SUBJECT: **Invitation for Bid # 10-0642-DS**
Oneco Terrace, Sunniland and Kirk Haven Water Phase 2
(Project No. 6025570 6.2)

ADDENDUM # 3

Subject: Responses to Pre-Bid and Bid Questions for Oneco Terrace Phase II

ONECO TERRACE WATERLINE REPLACEMENT (PHASE II)

JOB NO. 7880D.10
 DRAWING NO. P-08
 SHEET NO. 8 OF 14

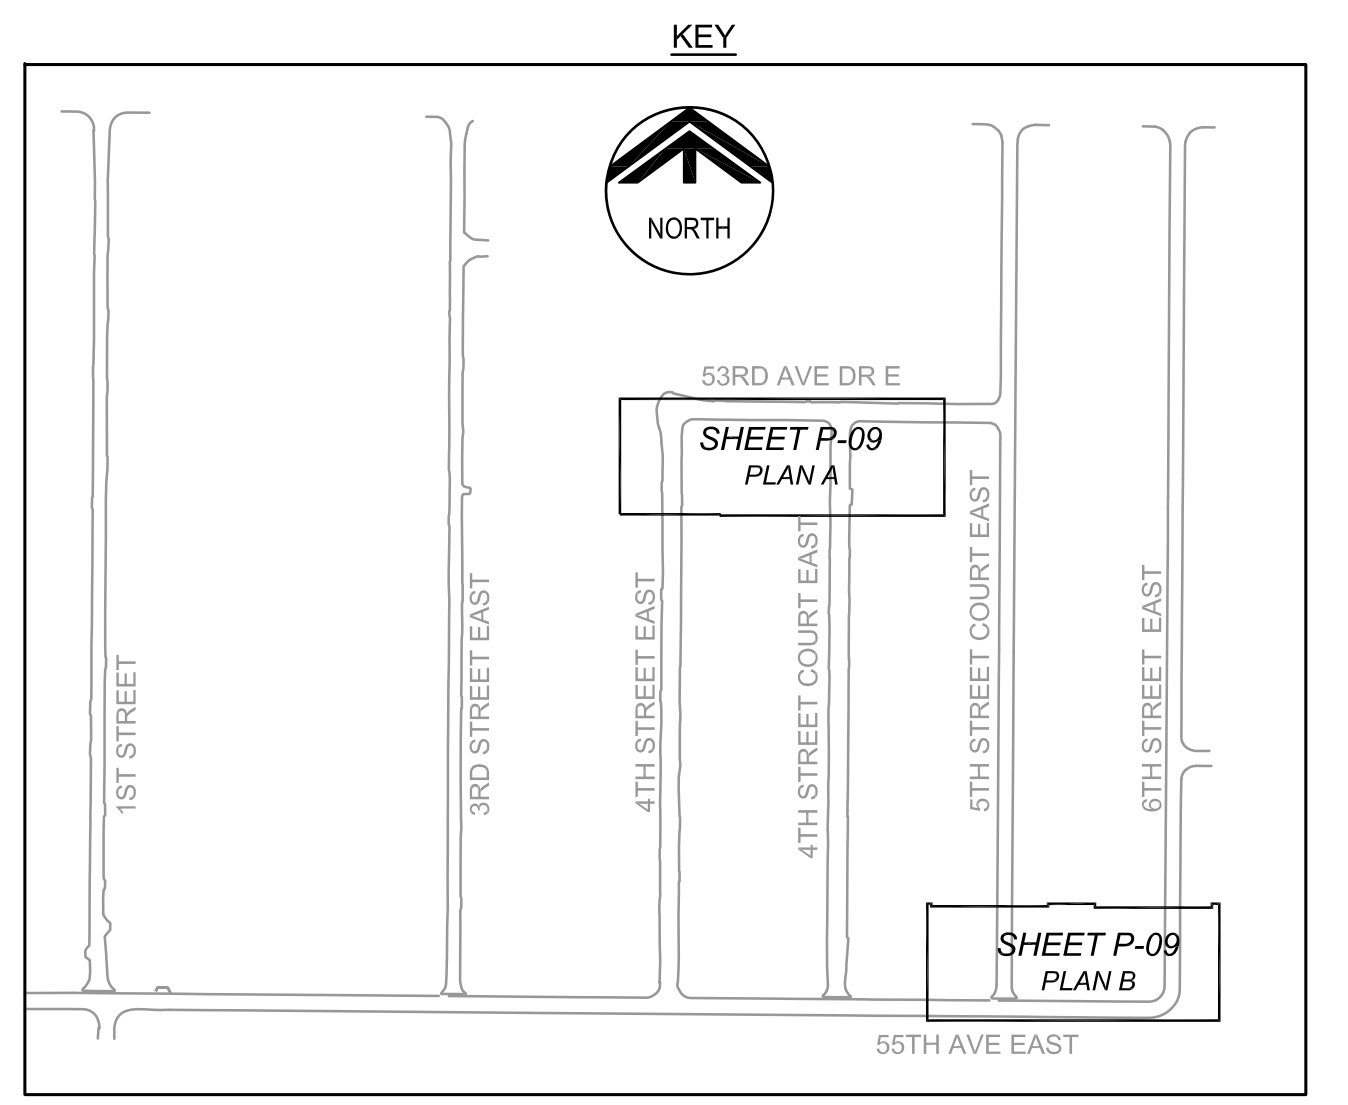
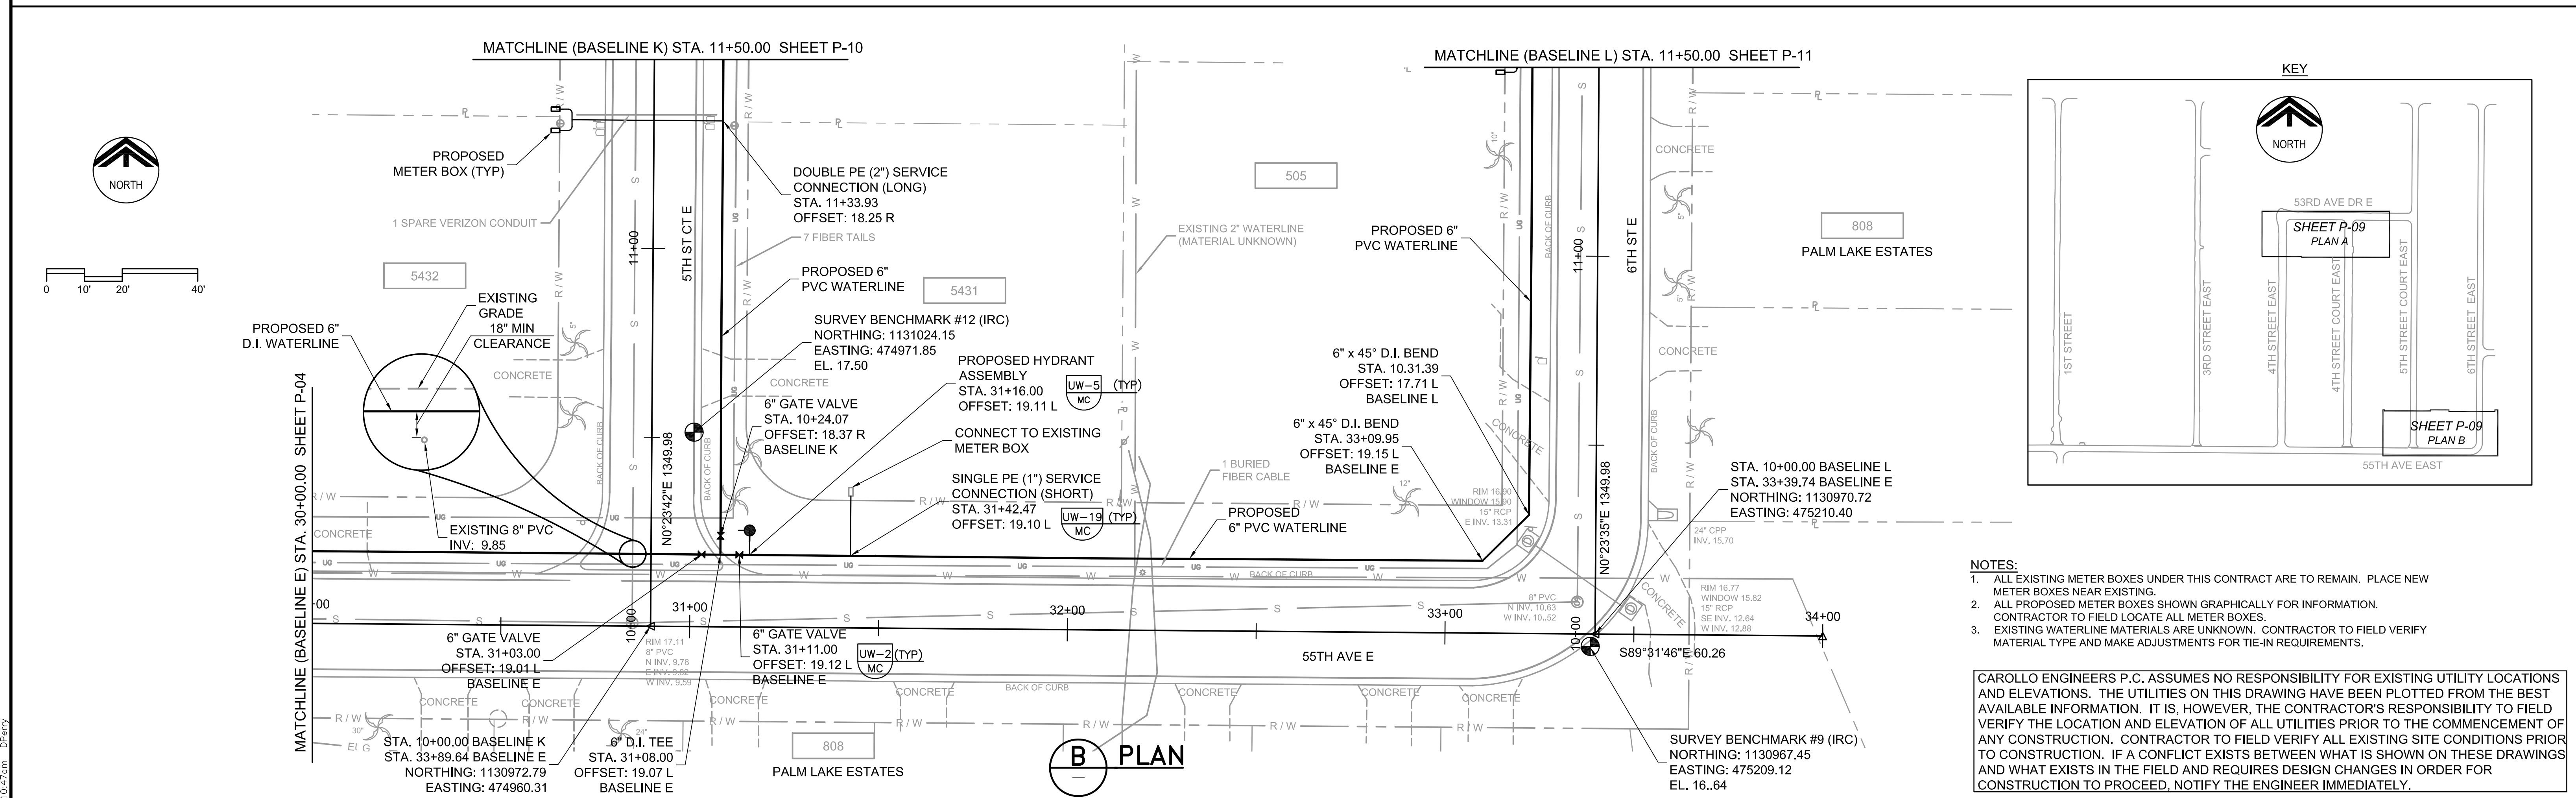
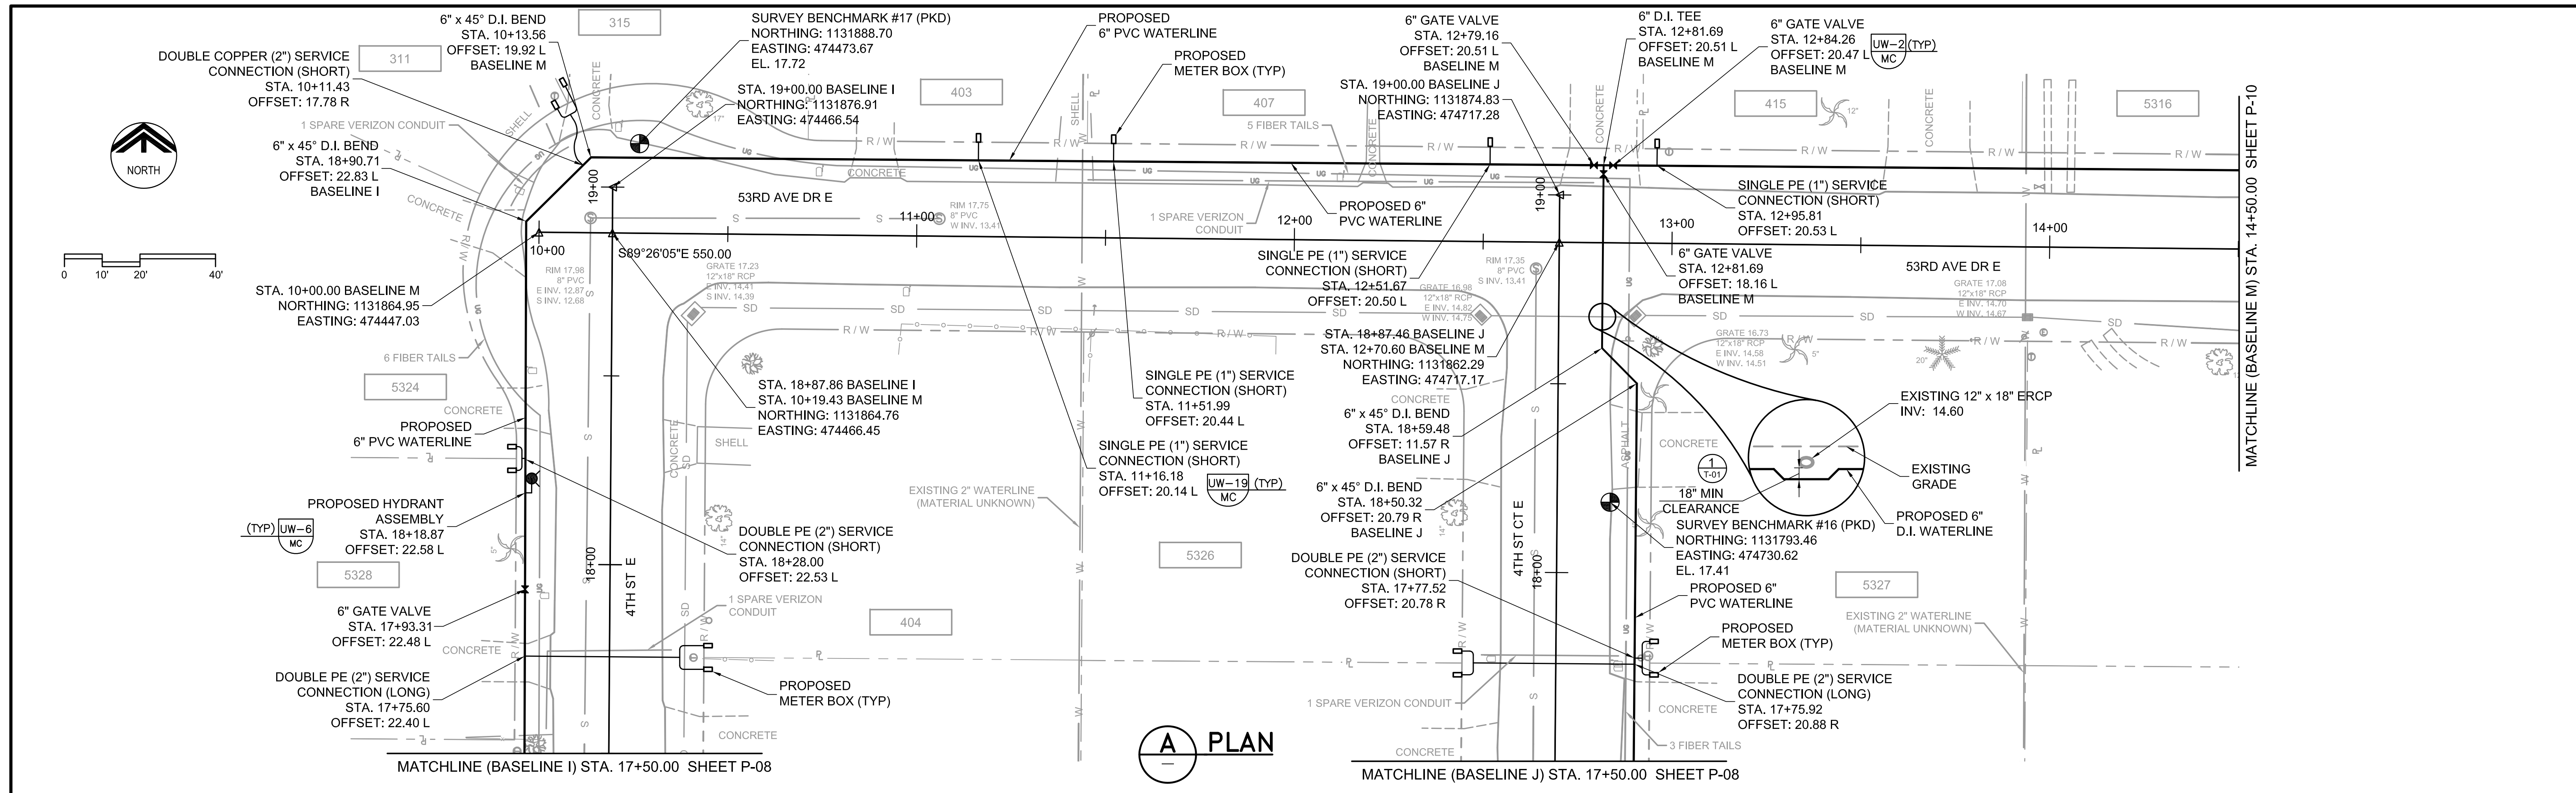
2. Sheets 4, 8, 9, 10, 11 of the plan set show Double PE services (short). There is no pay item for this service connection.

A bid item has been added for short side double PE services and quantities have been adjusted accordingly on the Bid Form.

DRAWING NO.
P-09

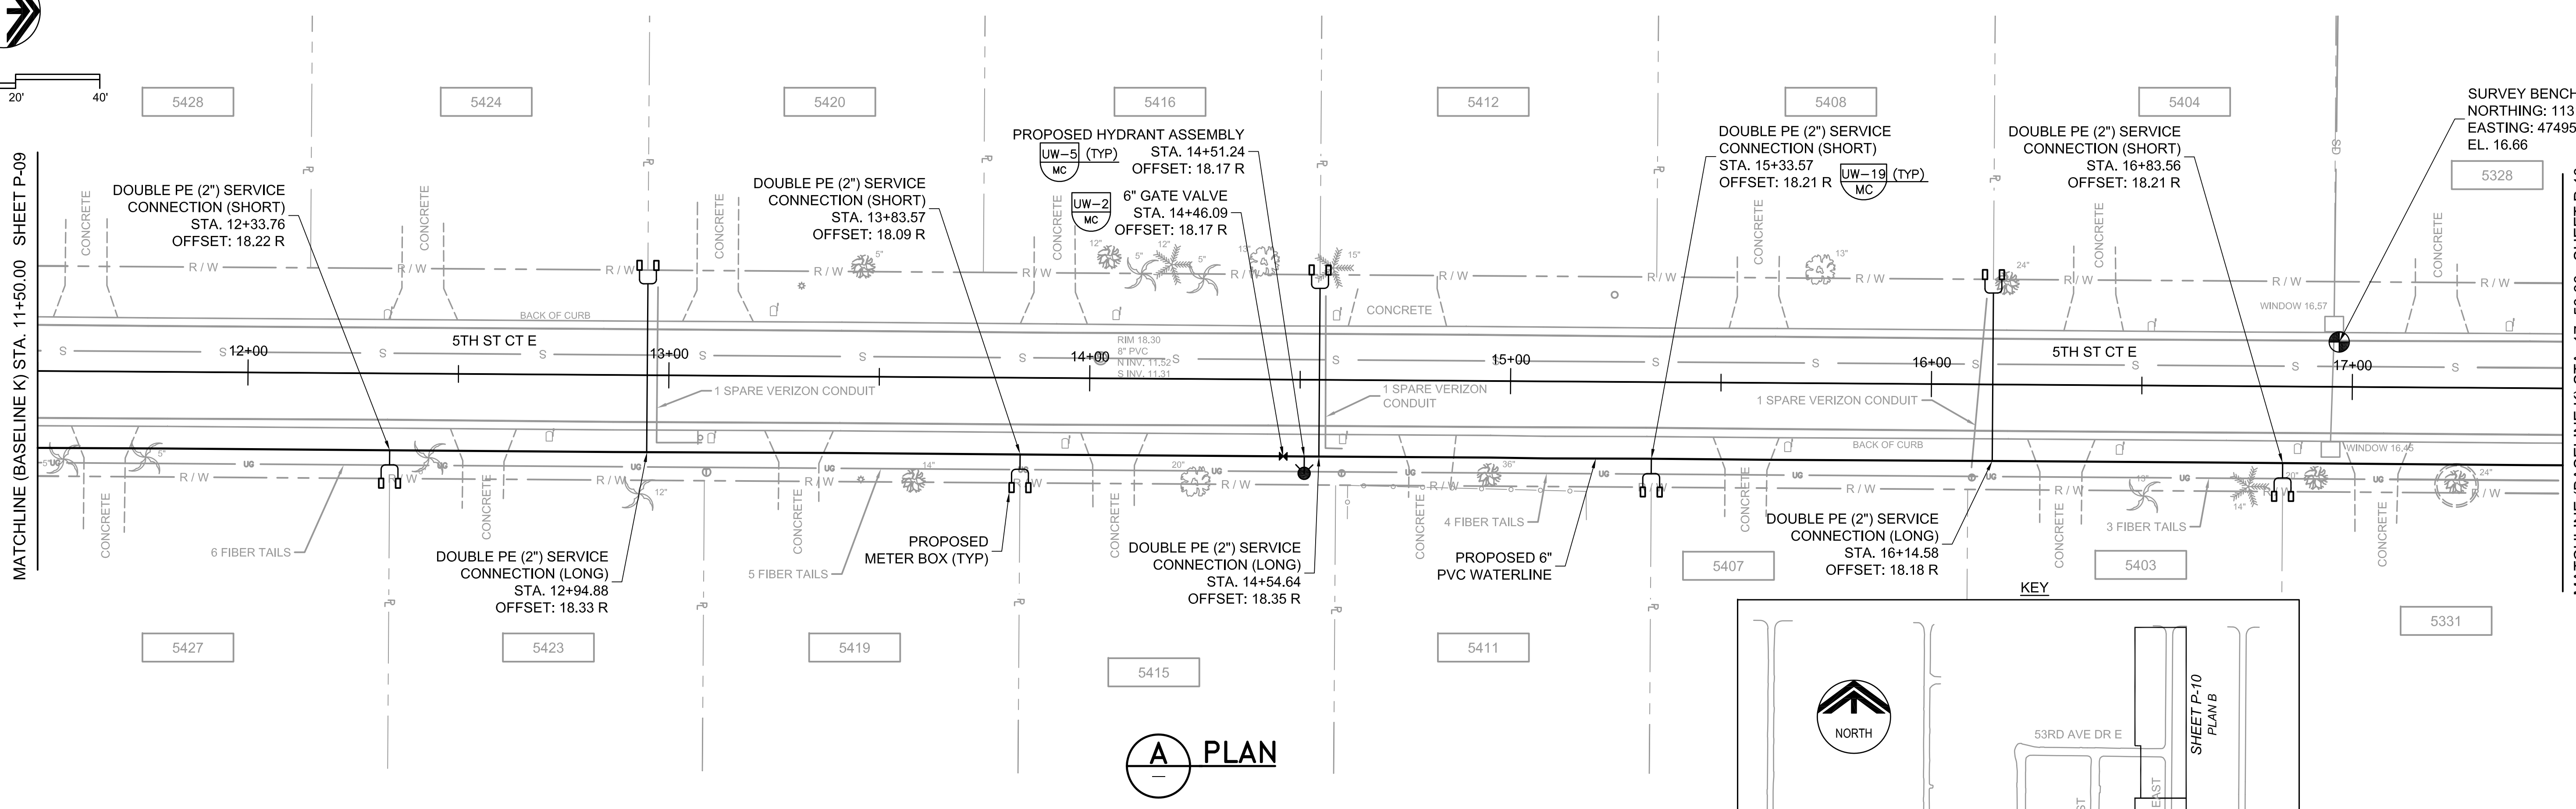
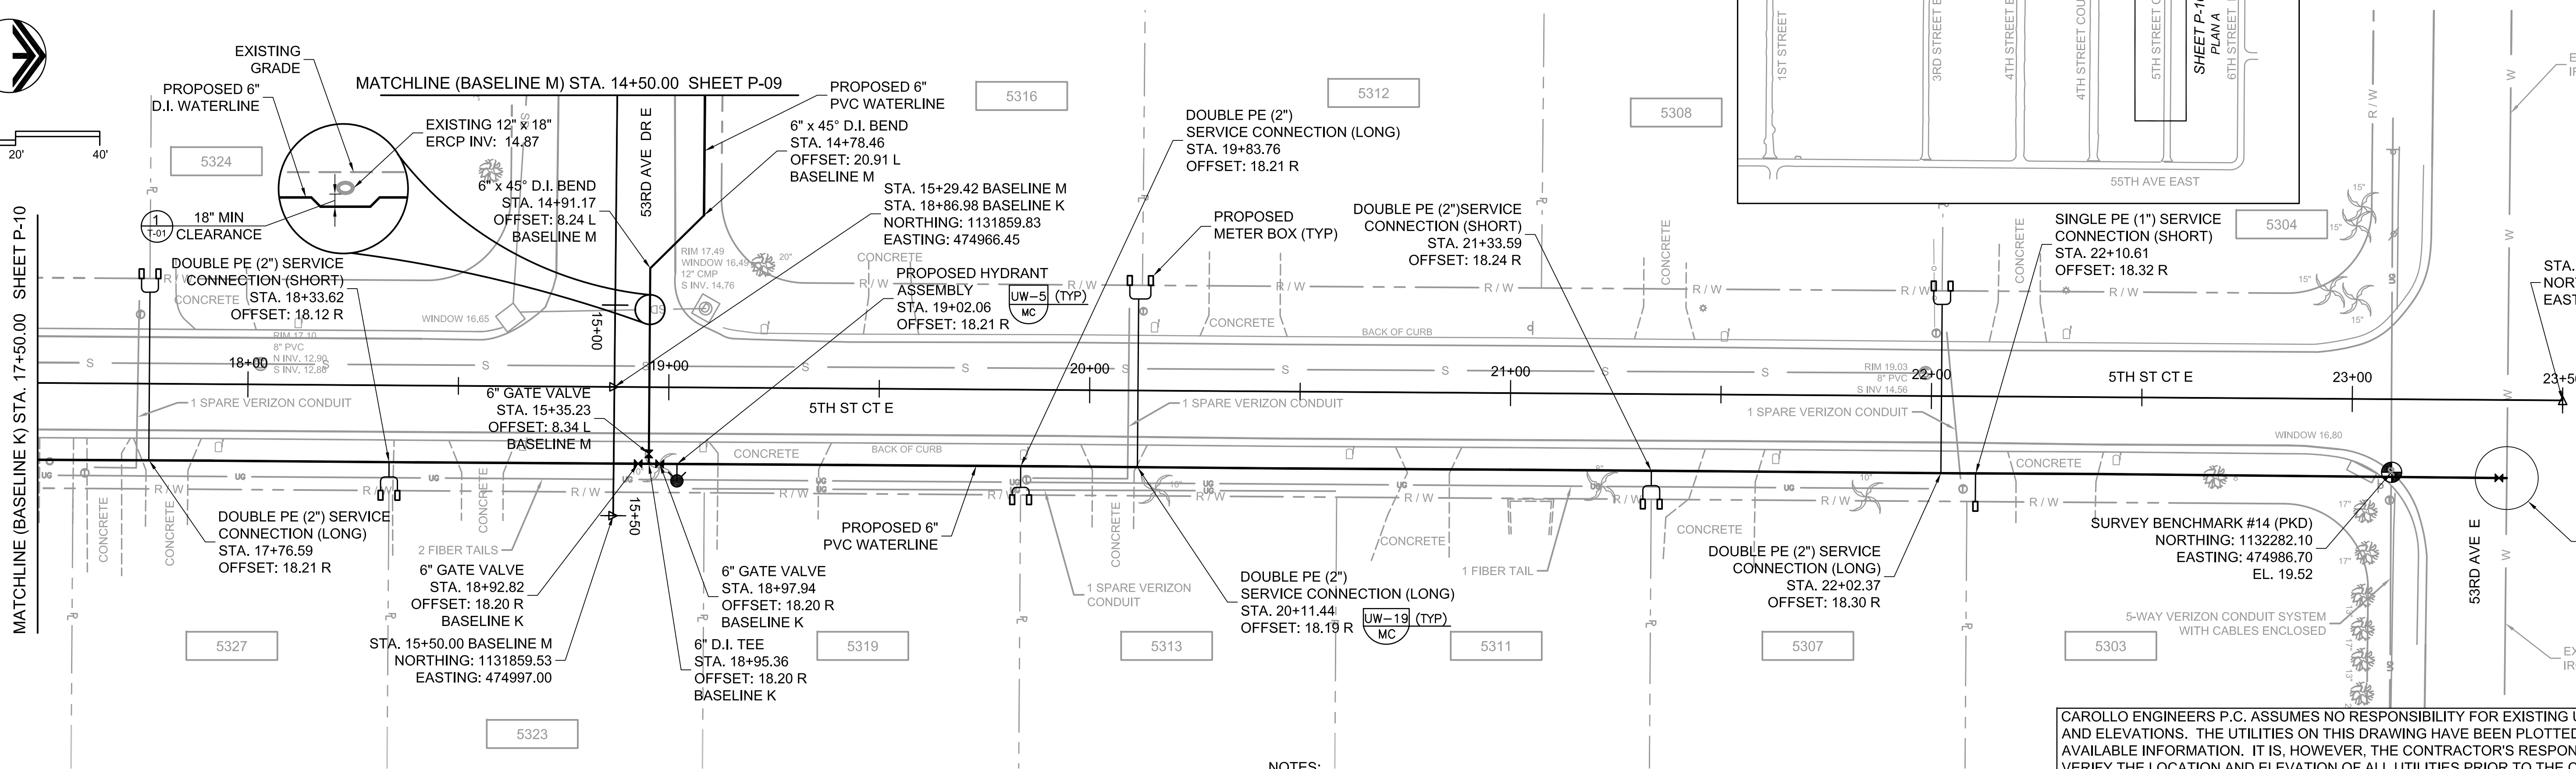
3. Sheets 4 and 9 of the plan set show Single PE services (long). There is no pay item for this service connection.

A bid item has been added for long side single PE services and quantities have been adjusted accordingly on the Bid Form.
